ADDENDUM #2
Electrical Enclosures & Fuel Station
Invitation to Bid: 13-011
6 March 2013

NAVY MOLE FUEL STAT. / FLOATING DOCK IMPR.
KEY WEST, FLORIDA
NAVAL FACILITIES ENGINEERING COMMAND
SOUTH DIVISION - CHARLSTON, SOUTH CAROLINA

DEPARTMENT OF THE NAVY
NAVAL FACILITIES ENGINEERING COMMAND
NAVAL FACILITIES ENGINEERING COMMAND SOUTHEAST
NAVAL AIR STATION JACKSONVILLE
KEY WEST, FLORIDA
NAVAL AIR STATION KEY WEST
MOLE PIER ELECTRICAL ENCLOSURES
DETAILS

DATE: JANUARY 25, 2012
PROJ: 460764
DWG: S-505
SHEET: 12 OF 19

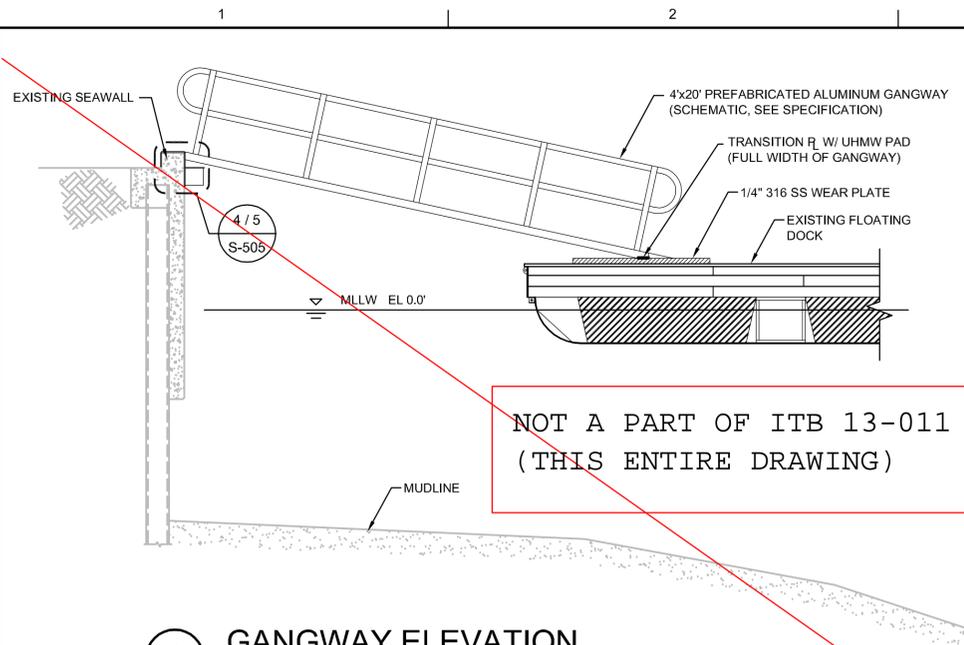
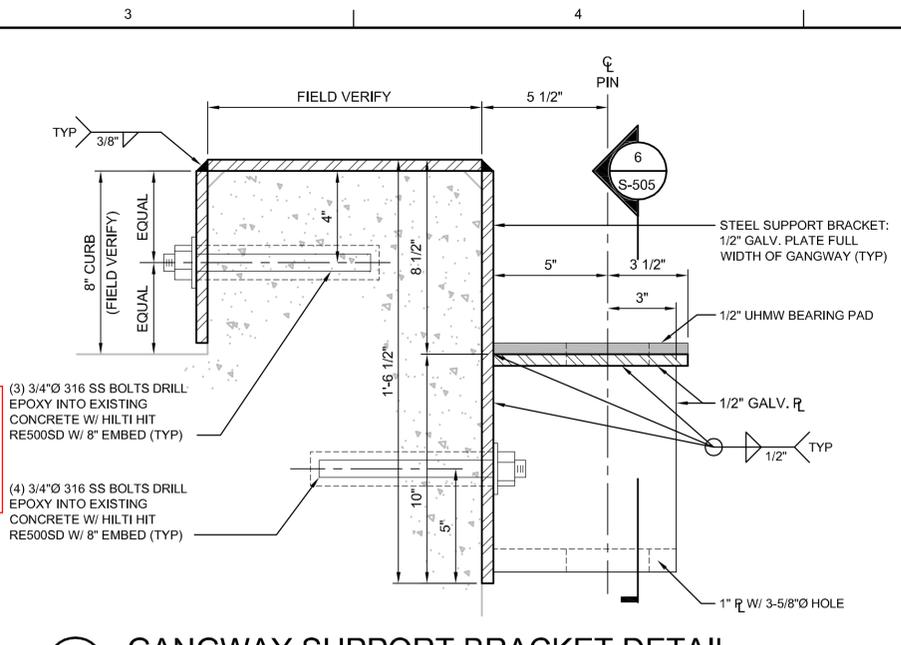
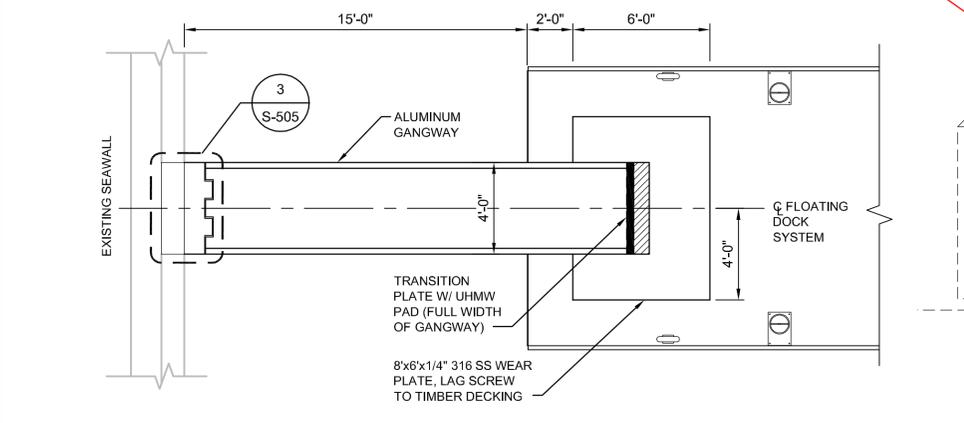
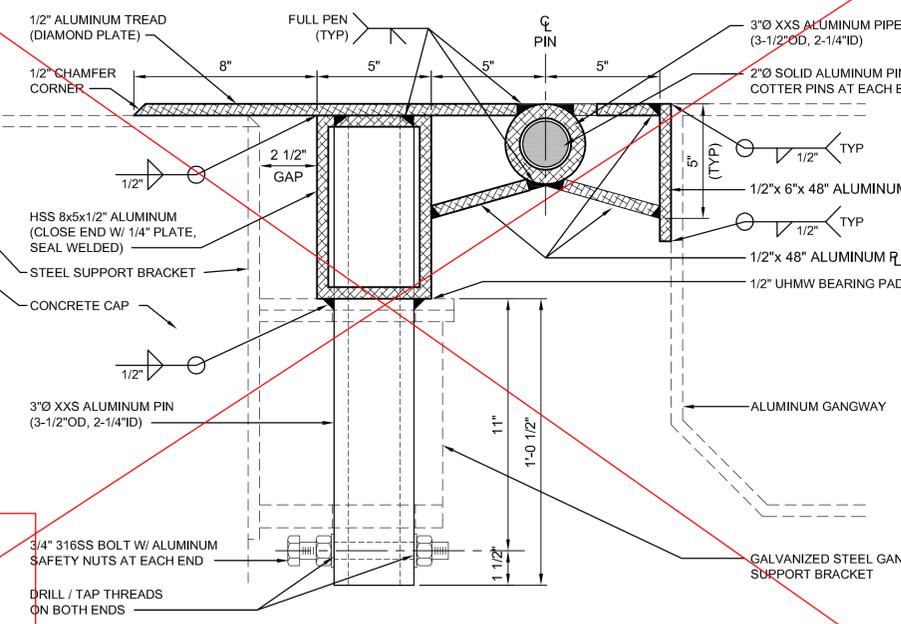
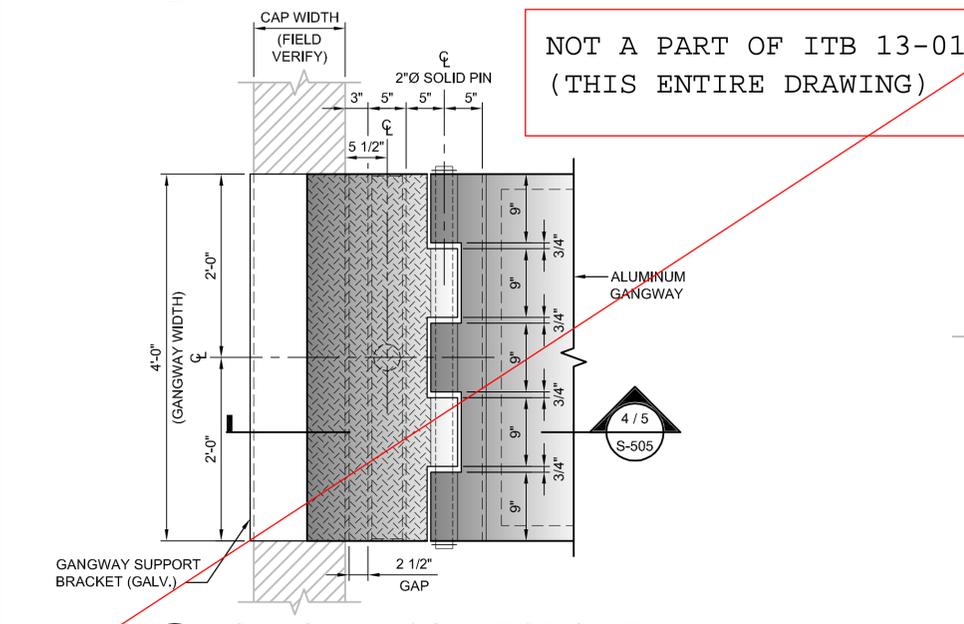
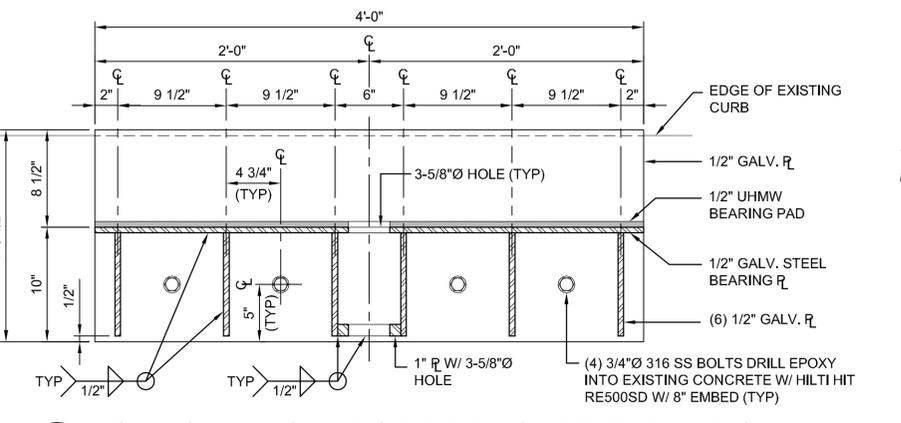
1. Replace Section F of Part 3 – Plans & Specifications with the attached (19 pages).
 - a. All work depicted on Sheets S403, S503, S504, S505, S506, S507, is to be excluded from this project in its entirety.

NOT A PART OF ITB 13-011
(THIS ENTIRE DRAWING)

SITE
ALTERNATE NO. 1
NEW FLOATING DOCK CONCEPT

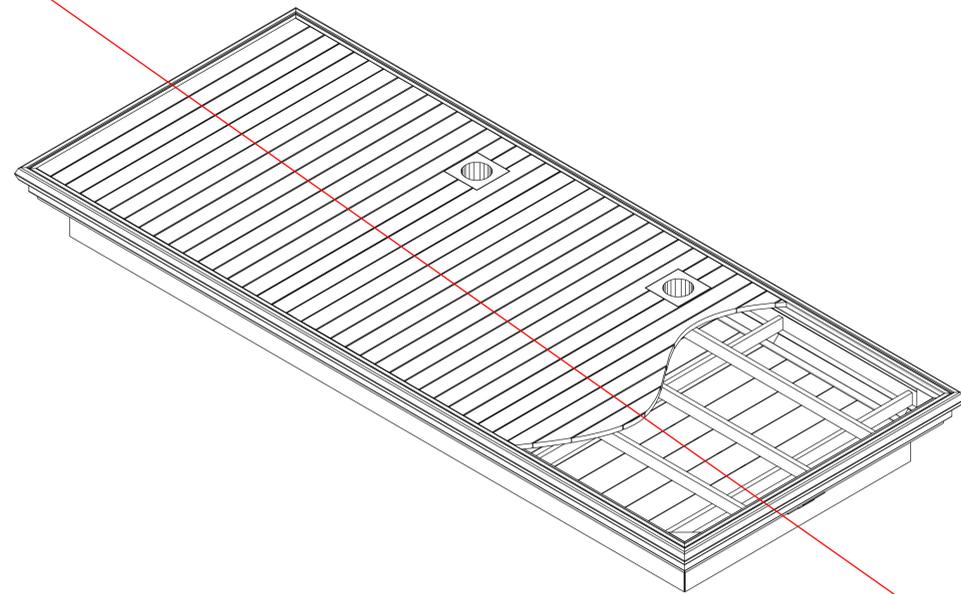
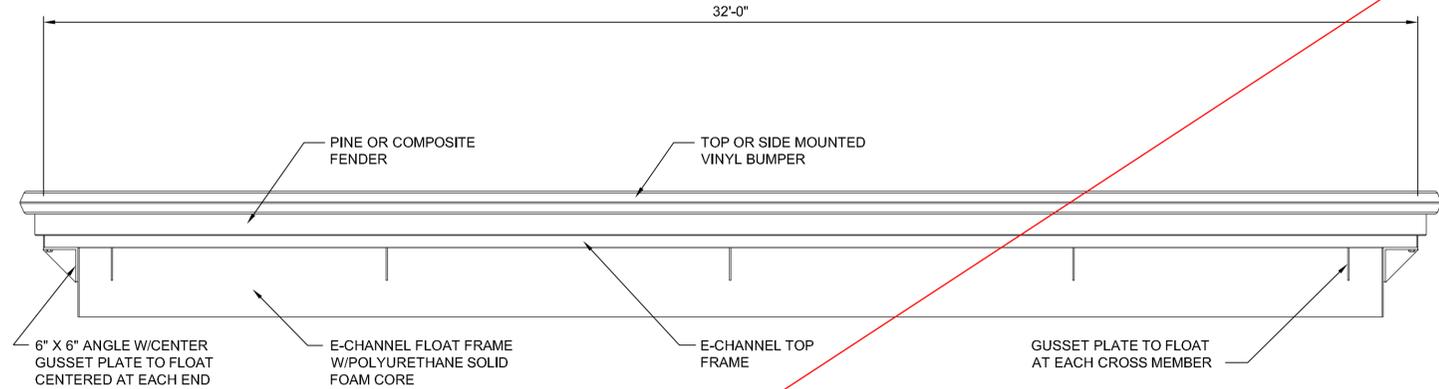
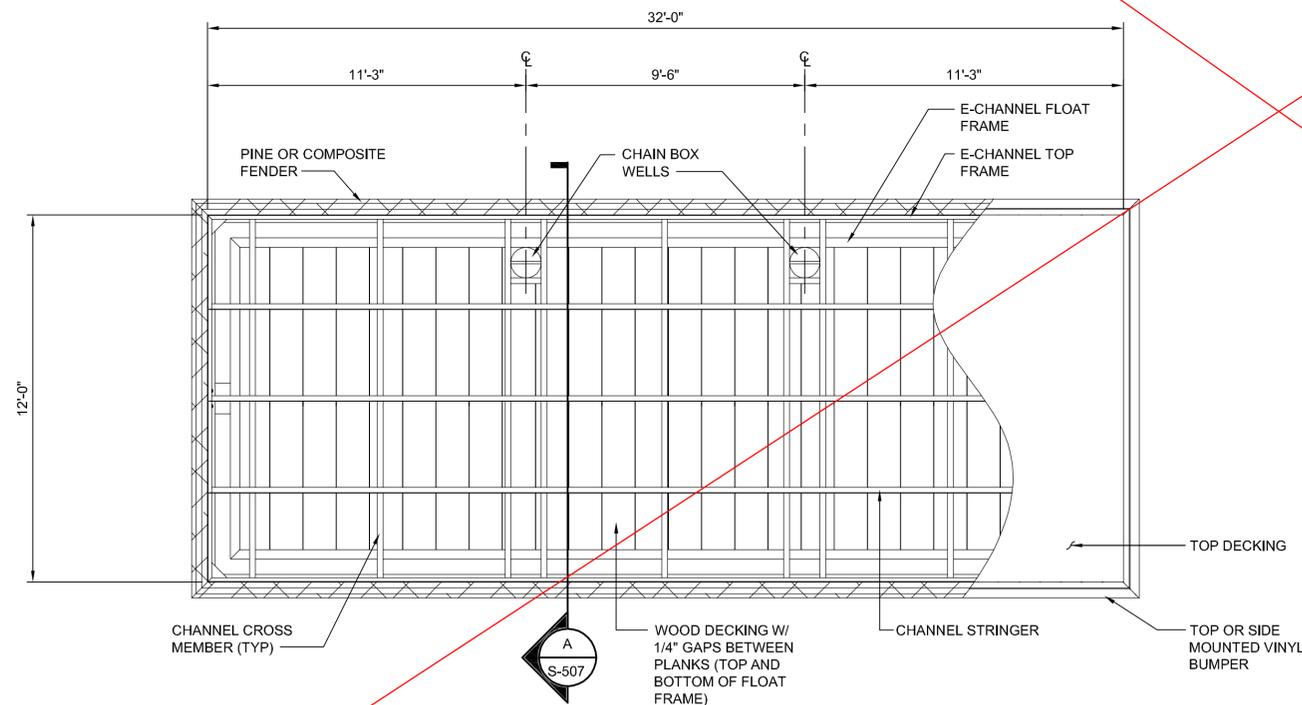
NOT A PART OF ITB 13-011
(THIS ENTIRE DRAWING)

SCALE: AS NOTED
PROJECT NO.: 1140628
CONSTR. CONTR. NO.: N69450-XX-C-XXXX
NAVFAC DRAWING NO.: 15071117
SHEET 31 OF 51
A501

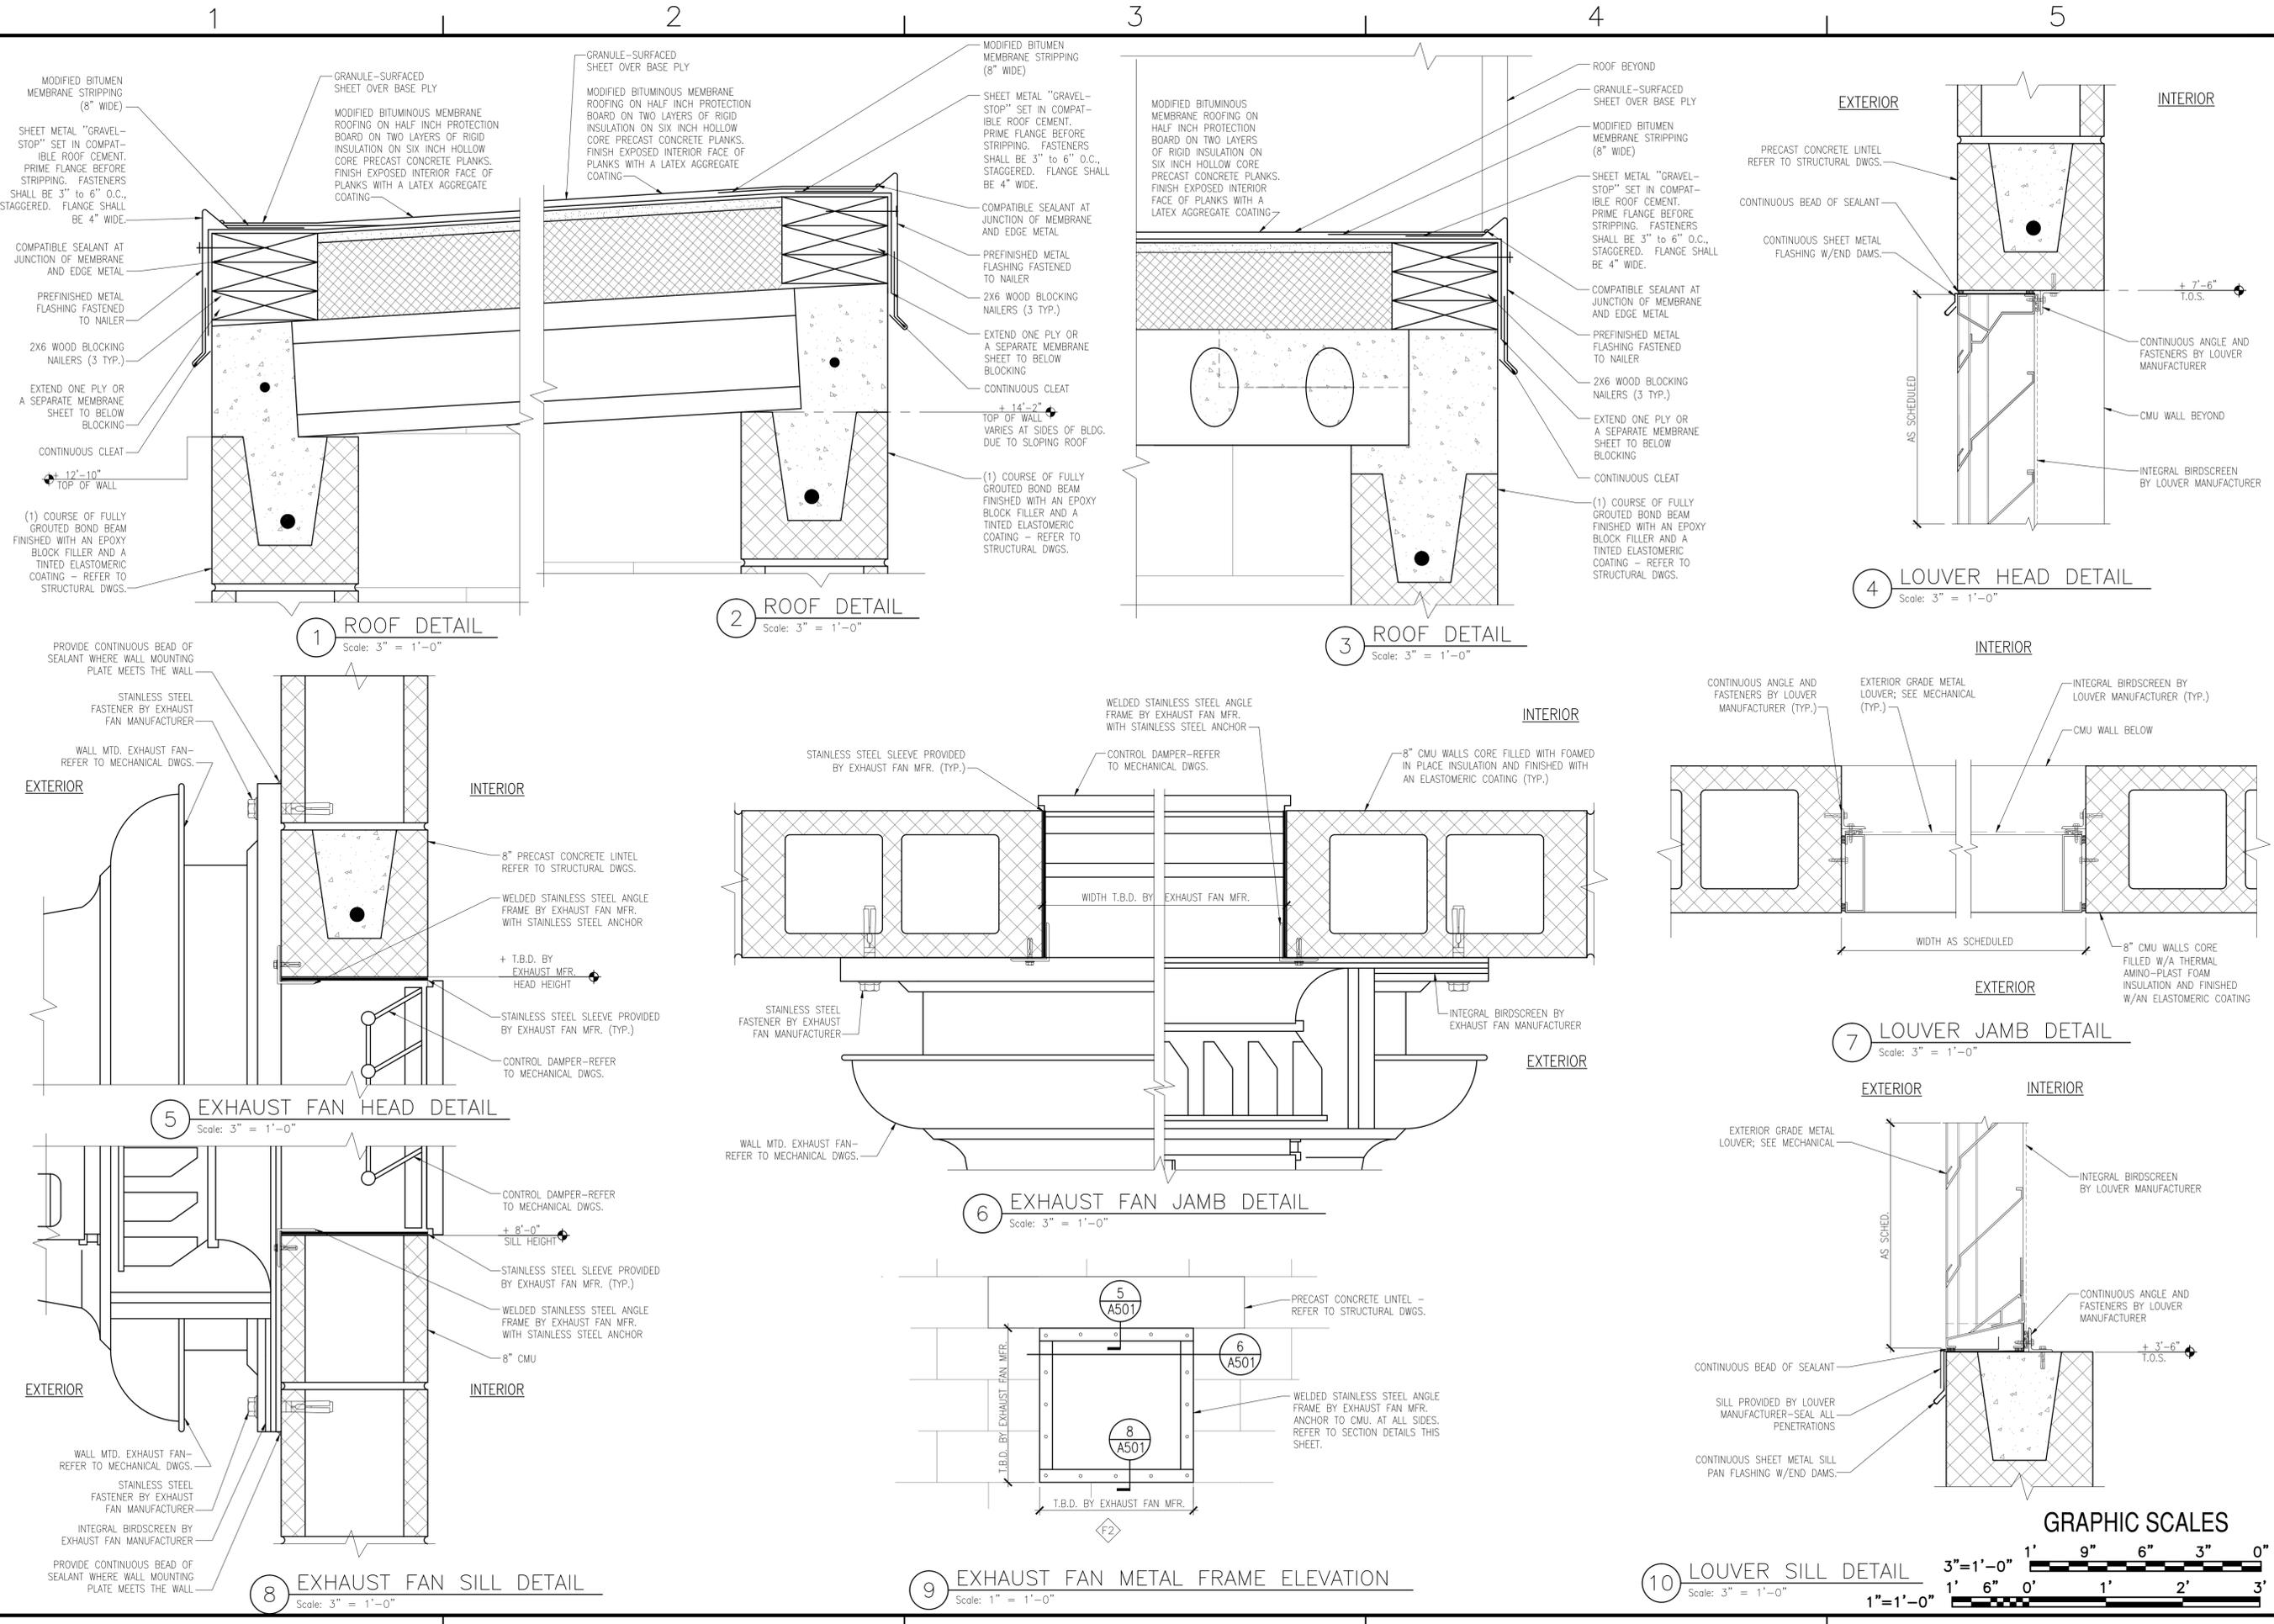
2. Replace Drawings A301, A302 and A501 of Part 3 – Plans & Specification Section E “Switchgear Enclosures” with the attached (3 pages).
 - a. These revised drawings reflect an updated waterproofing at the stem wall/CMU wall joint.
